STAFF REPORT FOR THE PLANNING COMMISSION MEETING OF MARCH 30, 2016

FILE NO: TPUD-16-012

REQUEST: To consider a request from Silver Oak Development, L.P. (property owner: Silver Oak Development Co., Ltd.) to modify the Silver Oak Planned Unit Development to add 31 single family residential lots in a new phase to be known as Silver Oak Phase 21, on property zoned Single Family 12,000 – Planned Unit Development (SF12-P).

DATE: March 11, 2016**TO:** Susan Pansky and Kathe Green – Planning**FROM:** Rory Hogen – Engineering**RE:** TPUD 16-012 Tentative PUD Map for Silver Oak Ph 21 PUD
Engineering Text for Planning Commission Staff Report

TENTATIVE CIRCULATION PATTERN
APN: 007-462-12
SILVER OAK PHASE 21 - OAK RIDGE DRIVE
CARSON CITY NV

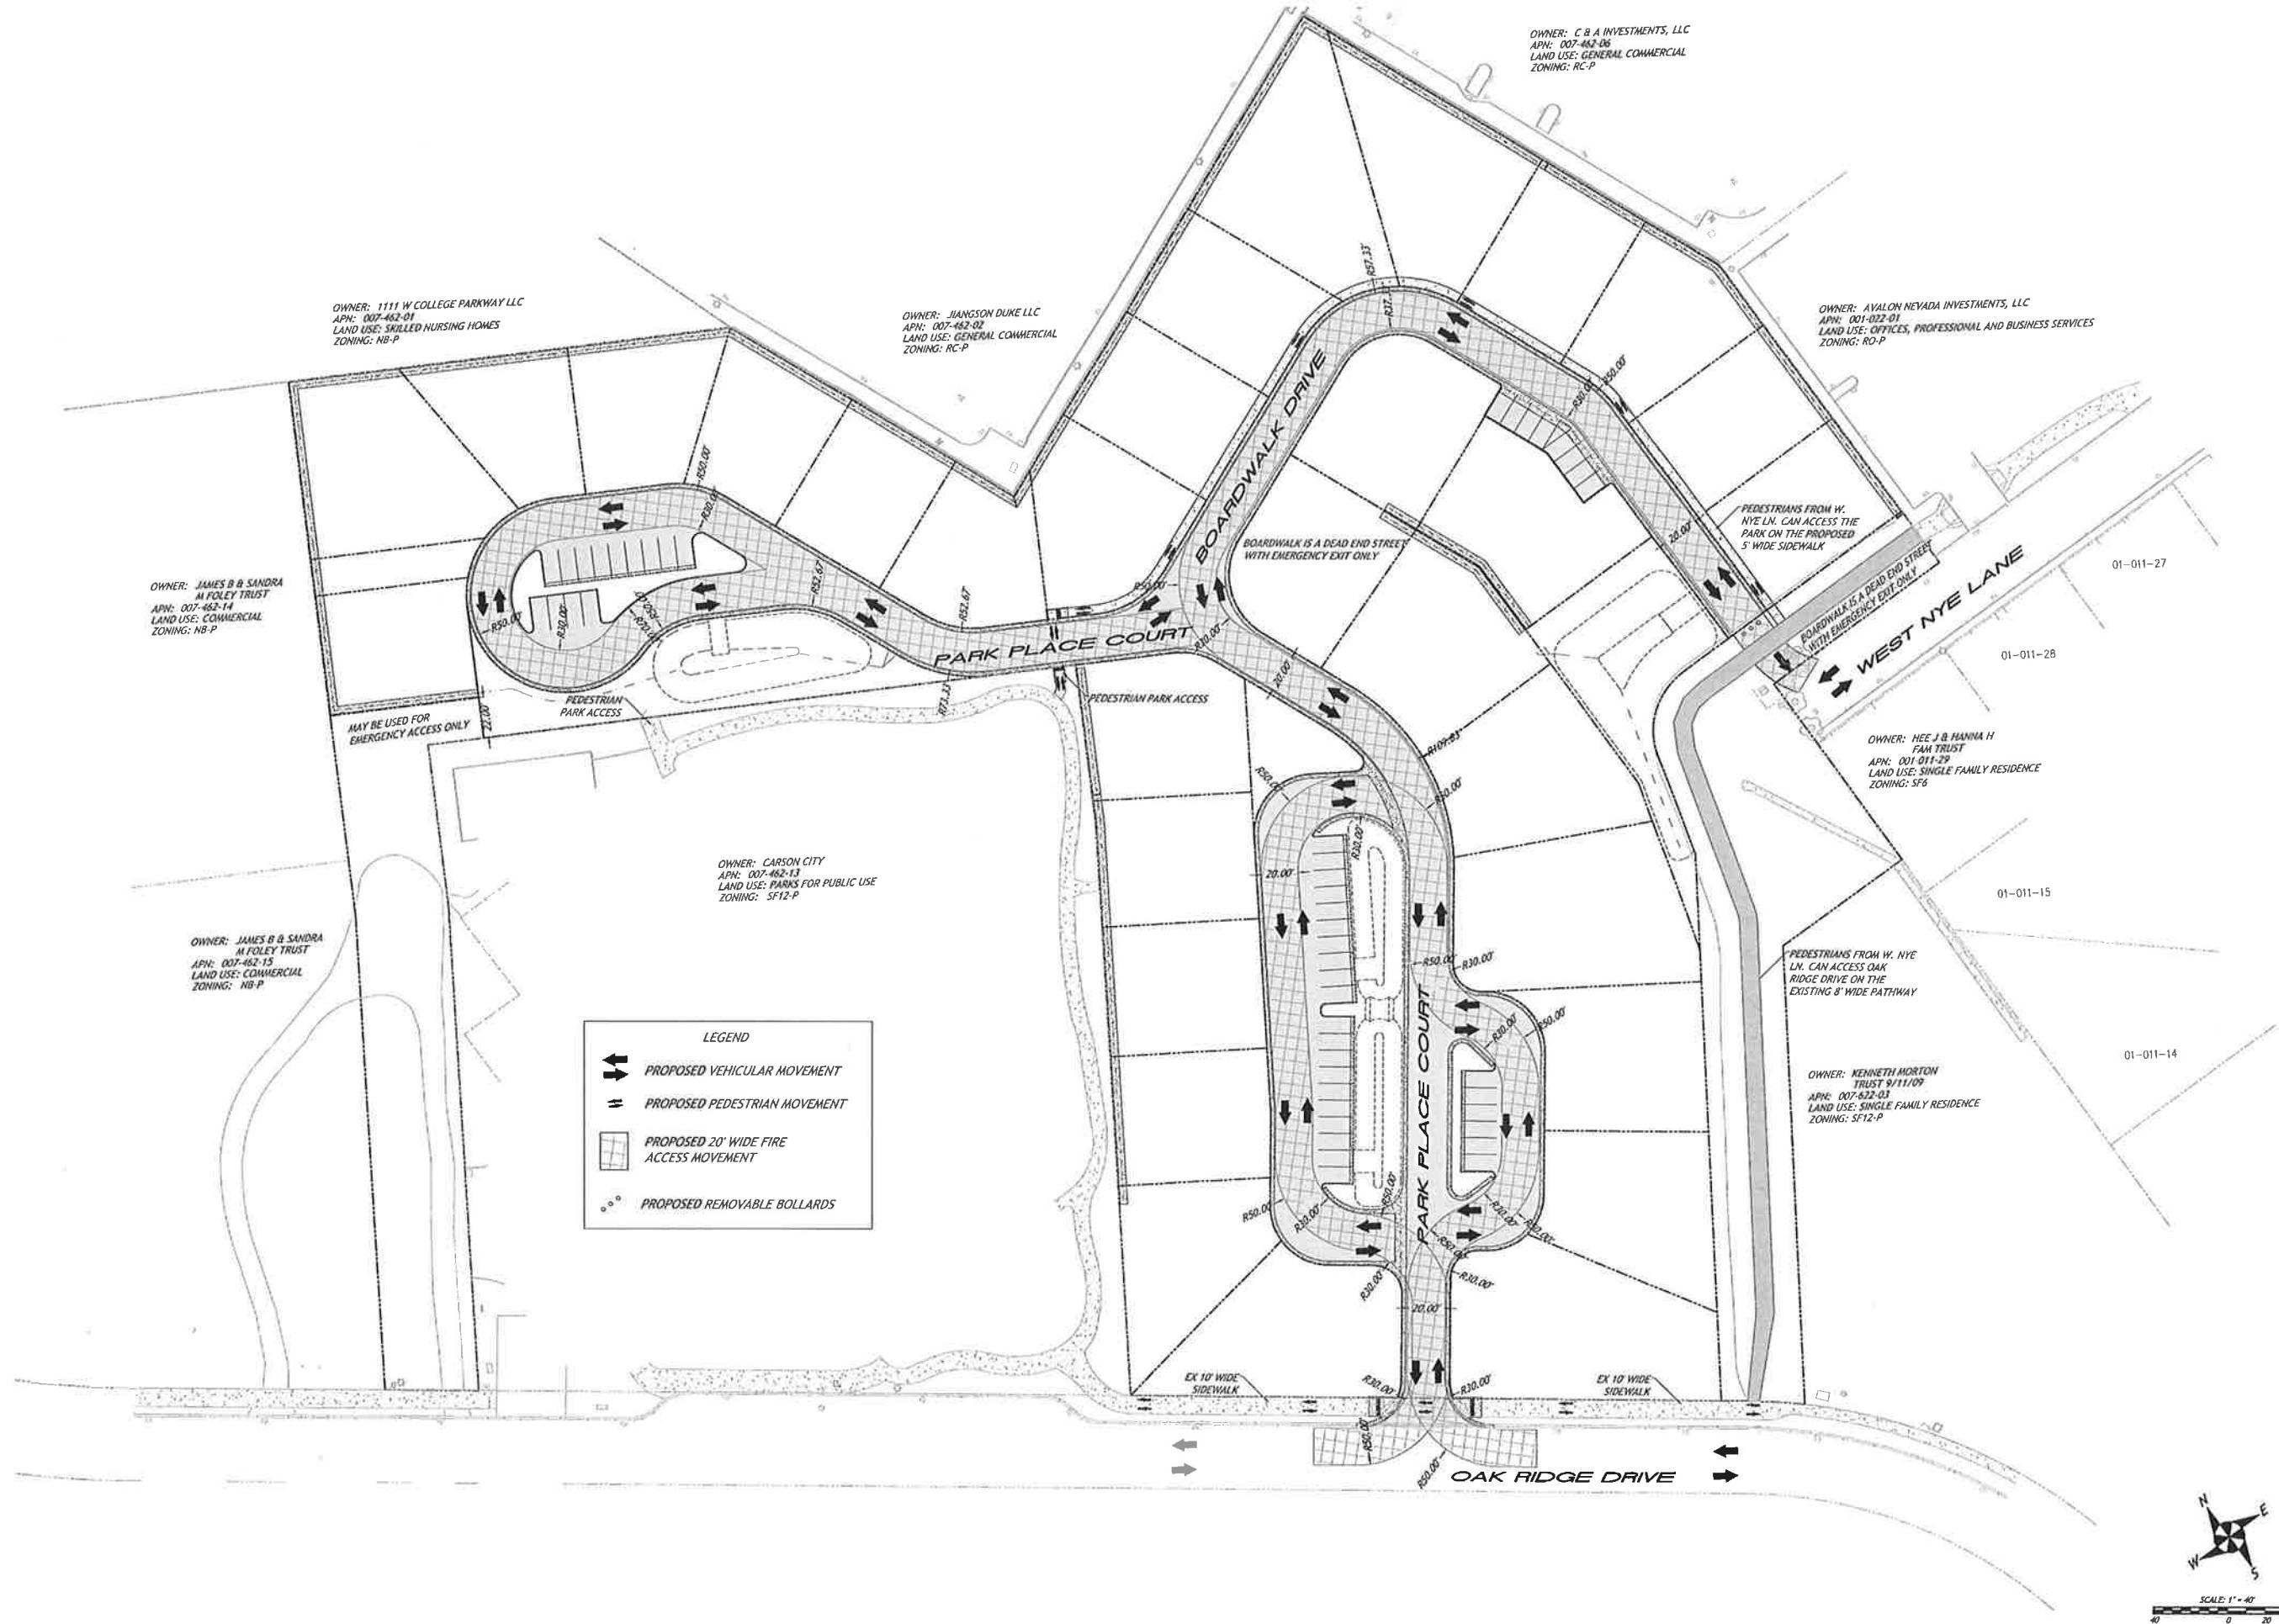
There are continued concerns with traffic and speeding in this area and specifically right in the area where this proposed development will access Oak Ridge Drive. The design of the neighborhood has limited connectivity, causing Oak Ridge Drive to be used as a through route, not just to access residences. The Public Works Department has received numerous complaints about this situation and recently conducted traffic counts which show that the speeding issue persists. The park is also very popular, and users of that park and residents in the homes recently constructed on the west side of Oak Ridge Drive are among those who have expressed concerns. Public Works implemented several measures last year in this area including a centerline, striping for the parking at the park, and concrete islands on the east side of the road. While those improvements were valuable and appreciated, concerns remain.

The solution is to modify the design of the planned development to line-up the new street with one of the existing driveways. I understand that the developer will view this change negatively, but if this change is not made, the City and the residents of this development and current residents will have to deal with additional negative traffic impacts indefinitely. The city would need to look into further modification of this road at city cost because the design did not appropriately address the concerns. There is already a difficult situation with safety concerns which is gotten worse with each development in this area. While this is not a “perfect” solution, I strongly believe we need to consider the traffic issues in this area very carefully.

There are continued concerns with traffic and speeding in this area and specifically right in the area where this proposed development will access Oak Ridge Drive. The design of the neighborhood has limited connectivity, causing Oak Ridge Drive to be used as a through route, not just to access residences. The Public Works Department has received numerous complaints about this situation and recently conducted traffic counts which show that the speeding issue persists. The park is also very popular, and users of that park and residents in the homes recently constructed on the west side of Oak Ridge Drive are among those who have expressed concerns. Public Works implemented several measures last year in this area including a centerline, striping for the parking at the park, and concrete islands on the east side of the road. While those improvements were valuable and appreciated, concerns remain.

The solution is to modify the design of the planned development to line-up the new street with one of the existing driveways. I understand that the developer will view this change negatively, but if this change is not made, the City and the residents of this development and current residents will have to deal with additional negative traffic impacts indefinitely. The city would need to look into further modification of this road at city cost because the design did not appropriately address the concerns. There is already a difficult situation with safety concerns which is gotten worse with each development in this area. While this is not a "perfect" solution, I strongly believe we need to consider the traffic issues in this area very carefully.

12. The new road which will serve as the access and egress point for the development will be implemented to align with an existing driveway on the west side of Oak Ridge Drive. The developer will implement a three-way STOP condition at the intersection of the new road being constructed where it intersects Oak Ridge Drive. The developer will submit plans for signing and striping to Carson City Development Engineering for approval prior to implementation.
